USB PD CTS ENGINEERING CHANGE NOTIFICATION FORM

Title: TEST.PD.PS.SNK.1

Applied to: USB PD CTS Q1, 2026 RC

Update PDO transition test per USB PD 3.2 v1.2 definition(Section 4.5).

Figure 4.16. Transition Diagram for Large-step voltage increase (Fixed or AVS > vSmallStep)

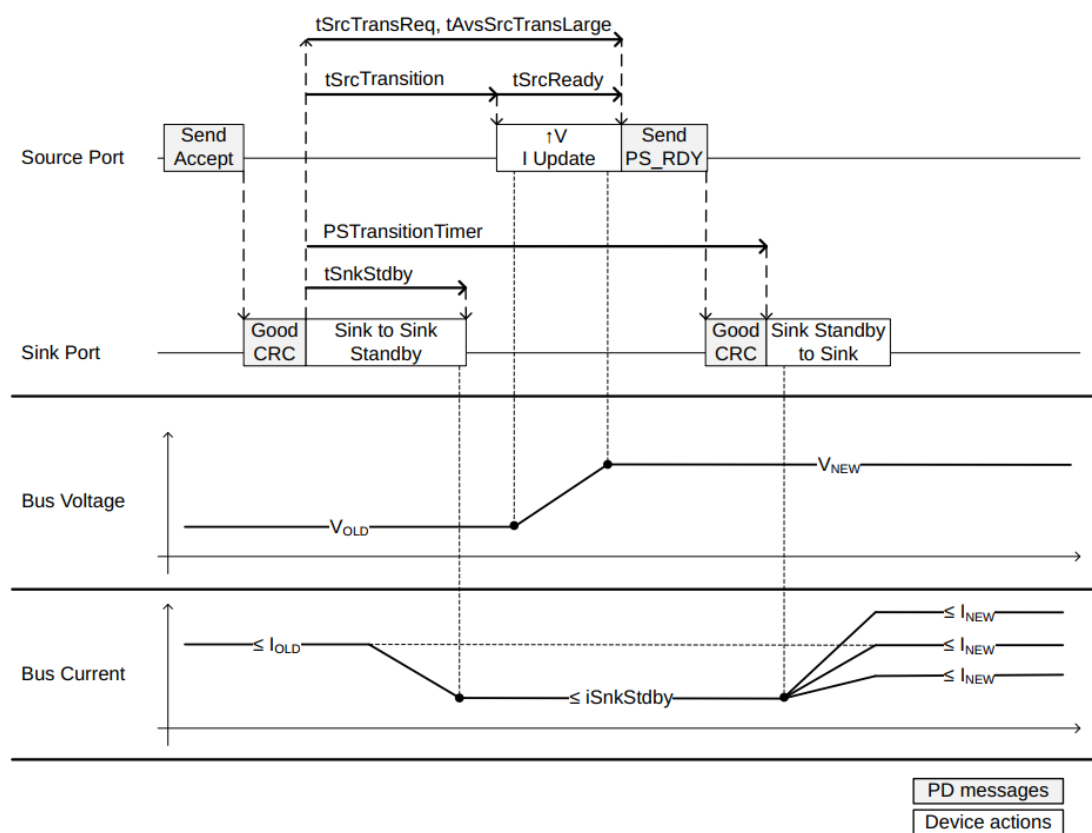
- 11. The Tester sends an *Accept* Message.
- 12. If a new PDO has been requested and the transition involves increasing the voltage:
 - a. If the transition is to a Fixed Supply PDO, or to an AVS APDO with a voltage change greater than vSmallStep:

- i. After a total of *tSnkStdbyn* from the EOP of GoodCRC Message acknowledging the *Accept* message, check that current drawn by the UUT does not exceed *iSnkStdby* max. [TEST.PD.PS.SNK.1#3]

- ii. Wait a nominal *tSrcTransition* from the *GoodCRC* Message and then change V_{BUS} voltage to the new requested value. For Fixed Supply PDO transitions, the Tester completes the voltage change and sends *PS_RDY* before *tSrcTransReq* expires. For AVS APDO transitions, the Tester shall complete the voltage change before *tAvsSrcTransLarge* expires.

- iii. As soon as the voltage on V_{BUS} has reached V_{NEW}, check that current drawn by the UUT does not exceed *iSnkStdby* max until *PS_RDY* is sent. [TEST.PD.PS.SNK.1#4]

Figure 4.17. Transition Diagram for Small-step voltage increase ($AVS \leq v_{SmallStep}$), current unchanged or increased

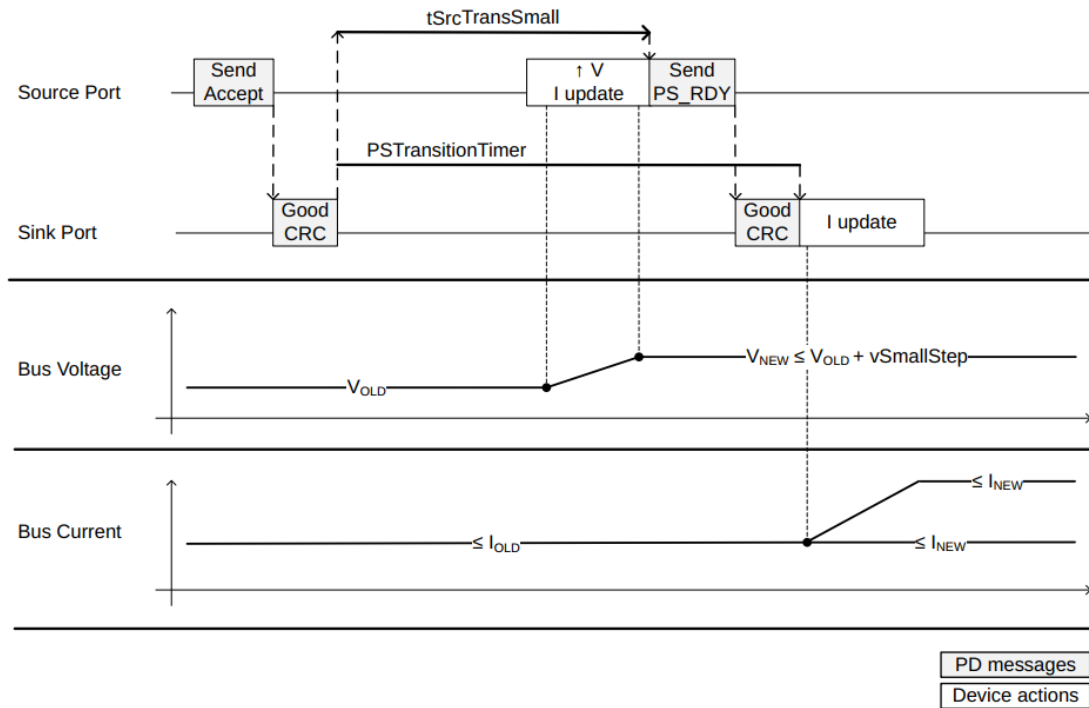
- b. If the transition is to an AVS APDO with a voltage change less than or equal to vSmallStep:
 - i. The Tester shall immediately begin changing V_{BUS} voltage after the GoodCRC Message acknowledging the *Accept* message. The tester shall complete the voltage transition and send *PS_RDY* before *tSrcTransSmall* expires.

- iii. If the newly negotiated current is unchanged or increased, check that the current drawn by the UUT does not exceed the previously contracted current during the transition after the EOP of GoodCRC acknowledging the *Accept* Message until the *PS_RDY* is sent by the Tester. [TEST.PD.PS.SNK.1#21]

Figure 4.18. Transition Diagram for Small-step voltage increase ($AVS \leq v_{SmallStep}$), current decreased

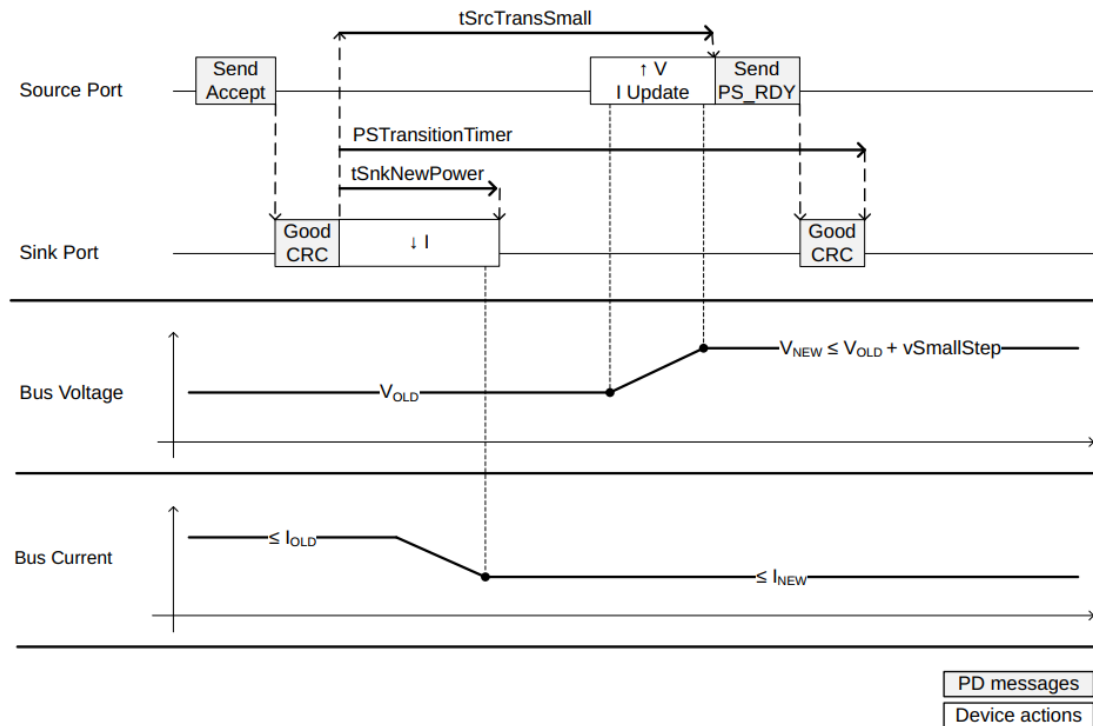
- ii. If the newly negotiated current is less than the previously contracted current, after *tSnkNewPower* from the EOP of GoodCRC acknowledging the *Accept* Message, check that the current drawn by the UUT does not exceed the newly negotiated current(I_{NEW}). [TEST.PD.PS.SNK.1#20]

Figure 4.19. Transition Diagram for voltage unchanged or decreased with current unchanged or increased

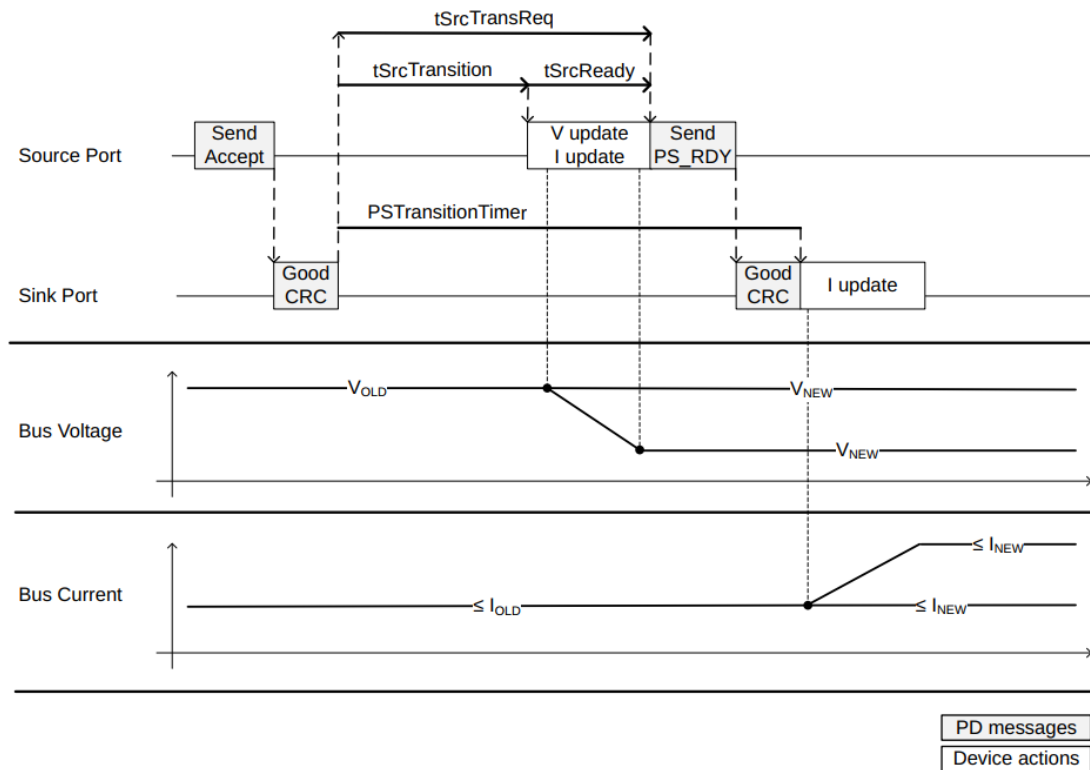
- ii. Check that the current drawn by the UUT does not exceed the max contracted current during and after the transition. [TEST.PD.PS.SNK.1#22]
- 13. If a new PDO has been requested and the transition involves unchanged or decreased voltage, or no new PDO is requested:

- a. If the newly negotiated current is unchanged or increased

- i. After $t_{SrcTransReq}$ max time period (before PS_RDY is sent), check that the current drawn from V_{BUS} does not exceed the previously contracted current. [TEST.PD.PS.SNK.1#5]

Figure 4.20. Transition Diagram for voltage unchanged or decreased with current decreased

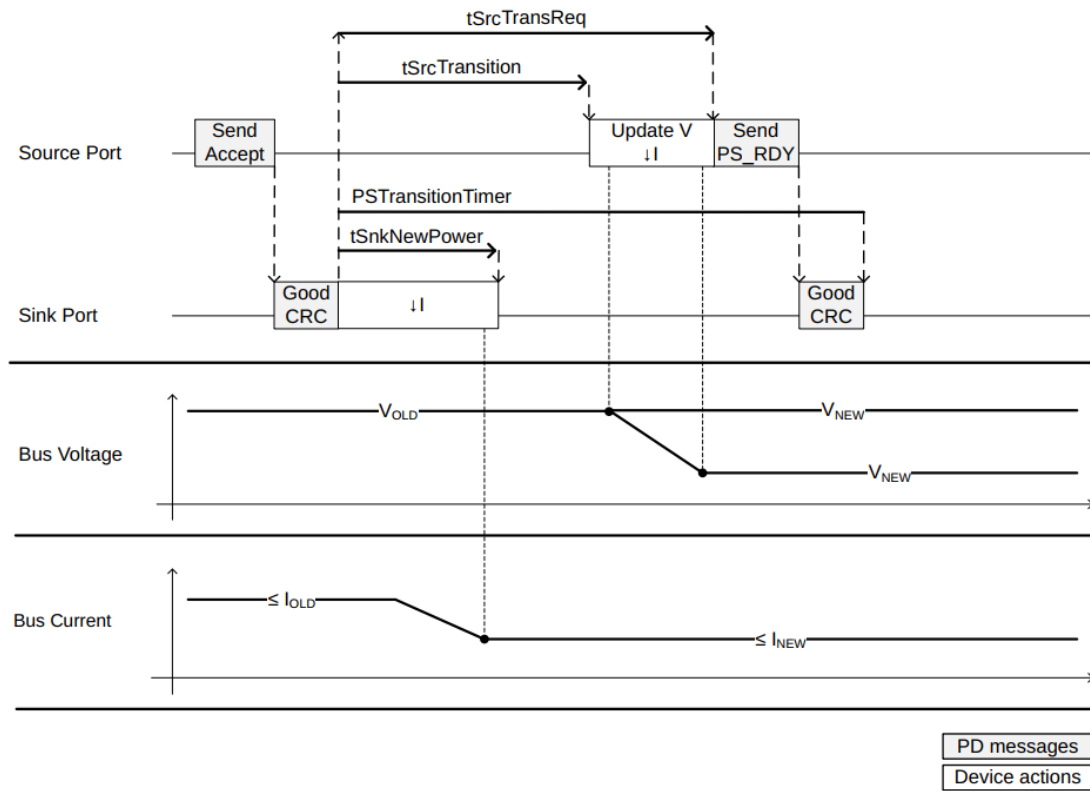
- b. If the newly negotiated current is decreased
 - i. After $t_{SnkNewPower}$ from the EOP of GoodCRC acknowledging the Accept Message, check that the current drawn by the UUT does not exceed the newly negotiated current (I_{NEW}). [TEST.PD.PS.SNK.1#23]

- ii. After $t_{SrcTransReq}$ max time period, check that the current drawn from V_{BUS} does not exceed the newly negotiated current (I_{NEW}). [TEST.PD.PS.SNK.1#24]
